SUBJECT: THREE MILE ISLAND NUCLEAR STATION, UNIT 1 - ISSUANCE OF
AMENDMENT RE: DELETION OF TECHNICAL SPECIFICATIONS FOR
REVIEW AND AUDIT, AND ADDITIONAL ADMINISTRATIVE CHANGES (TAC
NO. MD7320)

THREE MILE ISLAND NUCLEAR STATION, UNIT NO. 1

Amendment No. 269
License No. DPR-50

SAFETY EVALUATION BY THE OFFICE OF NUCLEAR REACTOR REGULATION
RELATED TO AMENDMENT NO. 269 TO FACILITY OPERATING LICENSE NO. DPR-50

Figure 3.1-2a

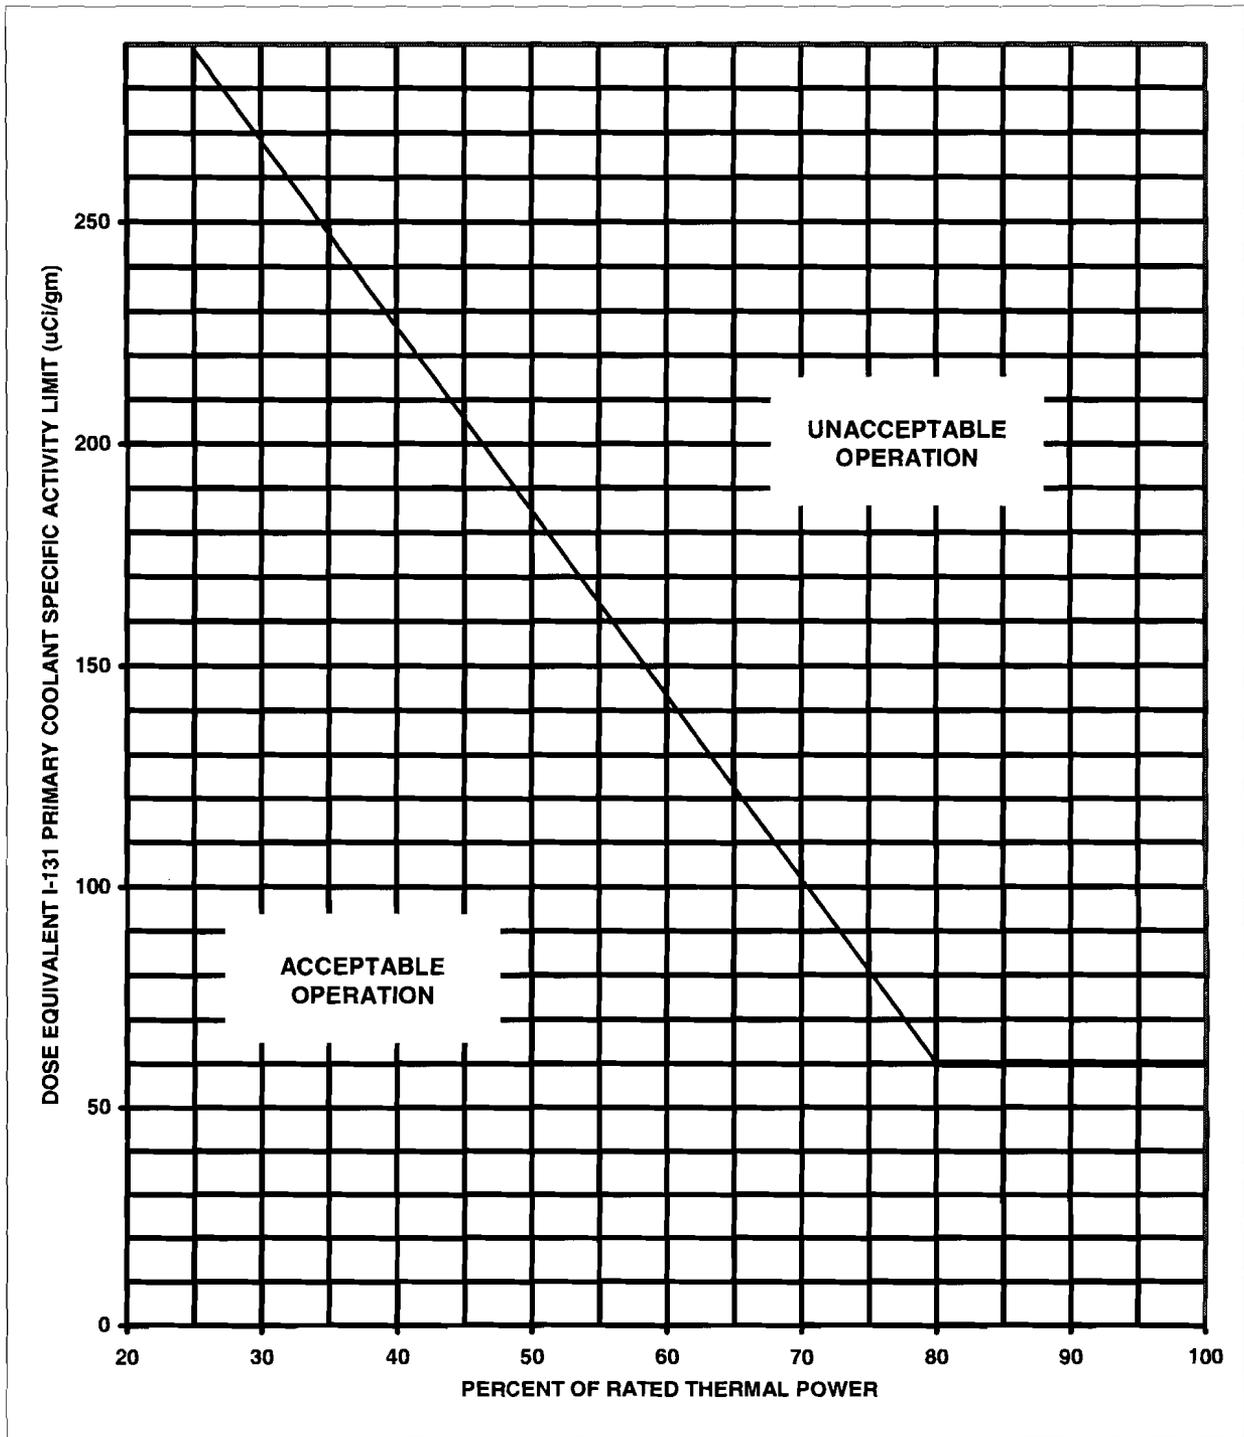
3.2.4 TS Figures 3.1-2a, 3.5-1, 3.5-2, and 3.5-3

TS Figures 3.1-2a, 3.5-1, 3.5-2, and 3.5-3 are being reprinted to improve legibility. These substitutions only impact the page readability, contain no technical changes, have no impact on plant safety and are, therefore, acceptable.
